February 29, 2024

**Re: Lorencito Canyon Mine (Permit No. C-1996-084)  
Review of Permit Renewal Application No. 5 (RN-5)  
Third Adequacy Review**

FIGURE 1. AREAS WHERE RILLS, GULLIES AND SPARSE VEGETATION HAS BEEN FOUND TO BE A PERSISTENT PROBLEM AT THE SITE ARE WITHIN THE DOTTED CIRCLE AREAS. BACKGROUND IMAGE IS THE 2020 ANNUAL REPORT MAP.

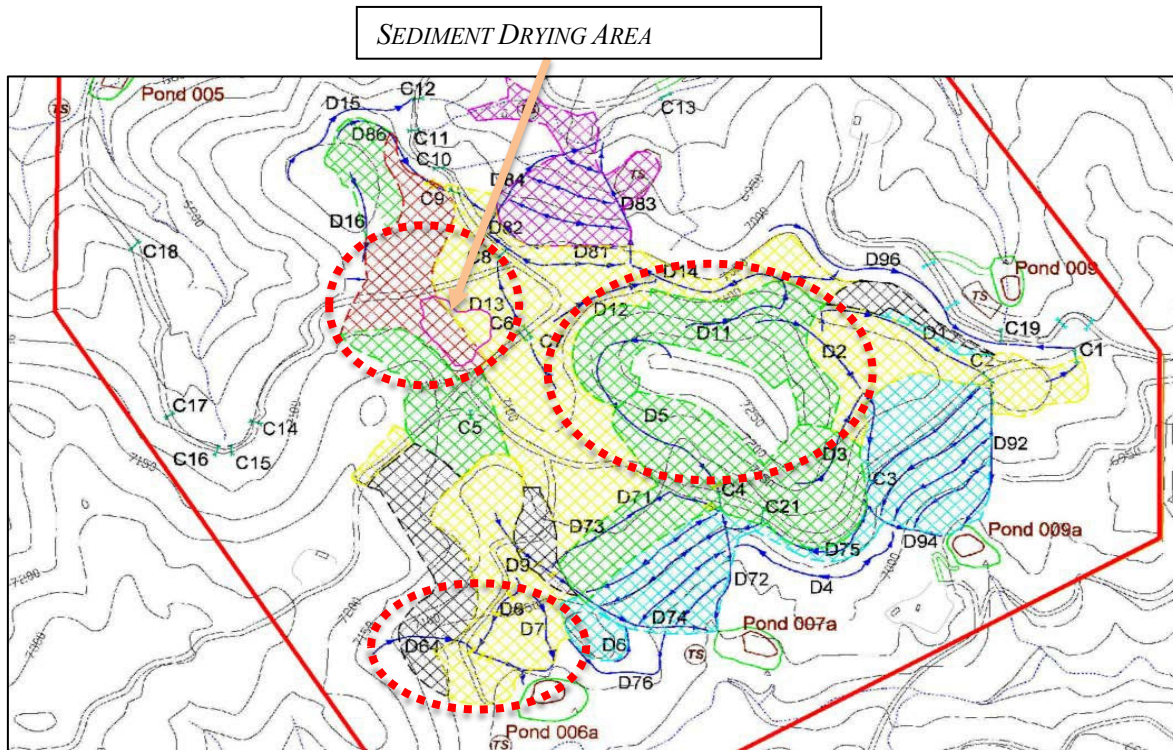
11. Significant rills, gullies, and areas with sparse vegetation have been noted in the reclaimed areas around the “Knob”, areas reported to have been reclaimed in 2006 and 2005 located above the area where pond and ditch cleanings are being stored, and areas reported to have been revegetated in 2007/2004 above Pond 006a. These areas are shown in the figures below. NECC has utilized several erosion control methods including the placement of straw waddles perpendicular to some of the eroded slopes, and the placement of brush within rills and gullies. The brush does seem to help prevent the rills from growing, and the brush seems to catch and hold soil and growth medium. Given the age of the reclamation of these areas in question, NECC will need to evaluate these areas to determine the best methods to fill, regraded, or otherwise stabilized these areas from erosion in accordance with Rule 4.14.6. Also, it is likely these areas will need to be reseeded in places given the sparse nature of the vegetation that has established. Please update the rill and gully plan to address how these areas will be stabilized in accordance with Rule 2.05.4(2)(c).

- *DRMS — “NECC states that NECC plans on addressing the rills and gullies by regrading or reseeding actions, and that this is planned to be addressed in 2023. NECC has a limited rill and gully plan included in the current page 2.05-69 of the PAP. In accordance with Rules 2.05.4(2)(c) and 4.14.6, please expand on this plan to include a proposal for addressing the specific areas highlighted in Figure 1. Be sure to identify these areas in the PAP as needing to be treated during this permit term. The Division requires NECC to create and submit a formal plan for addressing these issues at this time. This plan needs to be created and reviewed prior to approval of the permit renewal RN-5.”*

- NECC — “Page 2.04-59 has been revised to mention if more drastic erosion problems need to be addressed. For the areas mentioned in the adequacy review, NECC does plan on either addressing the rills and gullies by regrading and reseeding actions as noted in the plan. NECC is also thinking considering making revisions to the PAP to cut ditches in some areas that are steep and have tough time slowing water. NECC is planning on addressing these in 2023.”
